49 CFR Part 571

Federal Motor Vehicle Safety Standards; Bus Emergency Exits and Window Retention and Release

ACTION: Notice of proposed rulemaking (NPRM).

Figure 3D- REAR EMERGENCY EXIT WITHOUT REAR OBSTRUCTION

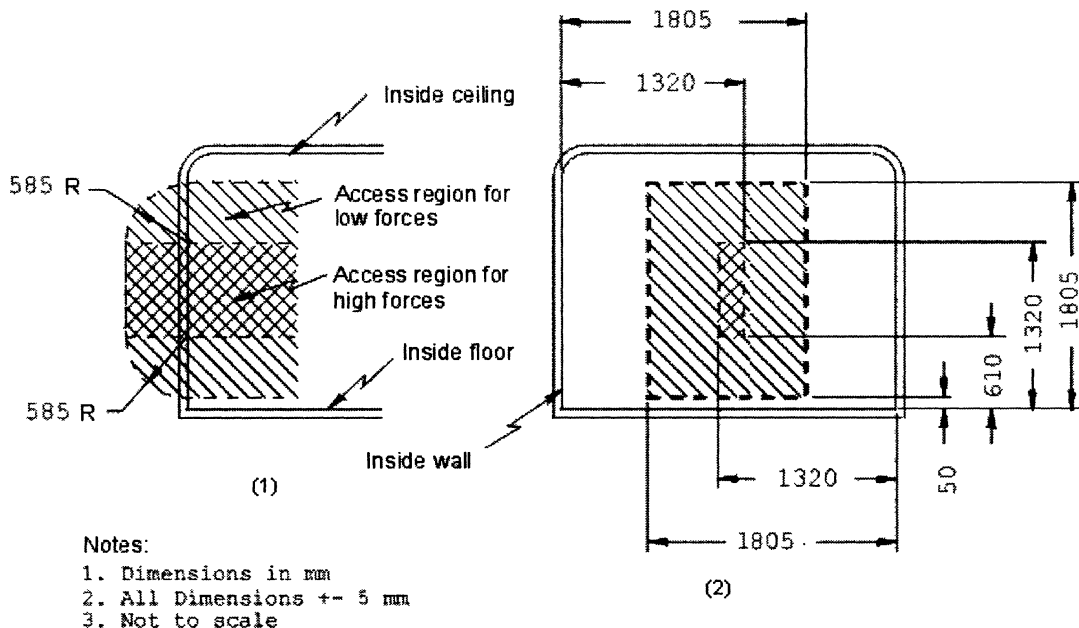
The School Bus Manufacturers’ Technical Council (SBMTC) petitioned the agency to amend FMVSS No. 217 to specify that the exterior release (handle) for school bus rear emergency exit doors may be located near the edge of the door on the side opposite the hinges. Specifically, SBMTC petitioned to amend S5.3.3.1(a) and one of the two drawings in Figure 3D.

S5.3.3.1(a) specifies that the manual interior and outside releases (handles) are located: “Within the high force access region shown in Figure 3A for a side emergency exit door, and in figure 3D for a rear emergency exit door.” Figure 3D consists of two drawings. The left-side drawing shows the vertical dimensions of the high force access region. As shown in the left-side drawing, the release (handle) may be located at any point from the left side of the door to the right. However, the right-side drawing, giving a different perspective of the rear exit, shows that the high force access region is a narrow area in the center of the door. Since S5.3.3.1(a) requires the interior and exterior releases (handles) to be “[w]ithin the high force access region shown in * * * figure 3D for a rear emergency exit door,” the releases must be in that narrow area in the center of the door shown in the right-side drawing of Figure 3D. As noted earlier, in actuality, SBMTC stated that manufacturers are “universally” placing the exterior releases on the side of the doors opposite the hinges.

SBMTC suggests that we reconcile the language of the standard with the practices of the industry and with what petitioner believes is best for safety. The petitioner suggests that we make the right-side drawing of Figure 3D apply only to the interior release (handle) and not to the exterior release. With regard to applying the right-side drawing to the interior release (handle), the petitioner believes there are reasons to require the interior release to be in the center of the door: the location ensures that the release is visible to bus occupants, and is not obscured by seat backs if the door is wider than the bus’s center aisle. Further, we note that the exit would be opened by a pushing rather than pulling

NHTSA agrees. We propose amending the standard to specify that the interior release (handle) for a rear emergency exit must be in the high force access region shown in both drawings of current Figure 3D, and that the exterior release for the exit must only be in the high force access region shown in the left-side drawing of current Figure 3D. Although no manufacturer currently places the exterior release in the center of the door, we request comment on whether we should require the exterior release to be no further than two inches away from the edge of the door. (To clarify the standard, NHTSA proposes that instead of having Figure 3D consist of two drawings, Figure 3D would be easier to understand if the left-side drawing were renamed Figure 3D(1) and the right-side drawing were renamed Figure 3D(2).) We tentatively agree that the school bus manufacturers' current practice of placing the exterior rear emergency exit door release (handle) near the edge of the door on the side opposite the hinges better meets the need for safety than placing the exterior release in the center of the door. Releases (handles) placed opposite the hinges would require less force to pull open the door for persons outside the school bus.

(a) *Location:* Within the high force access region shown in Figure 3A for a side emergency exit door, within the high force access region shown in both Figure 3D(1) and Figure 3D(2) for an interior release mechanism for a rear emergency exit door, and within the high force access region shown in Figure 3D(1) for an exterior release mechanism for a rear emergency exit door.
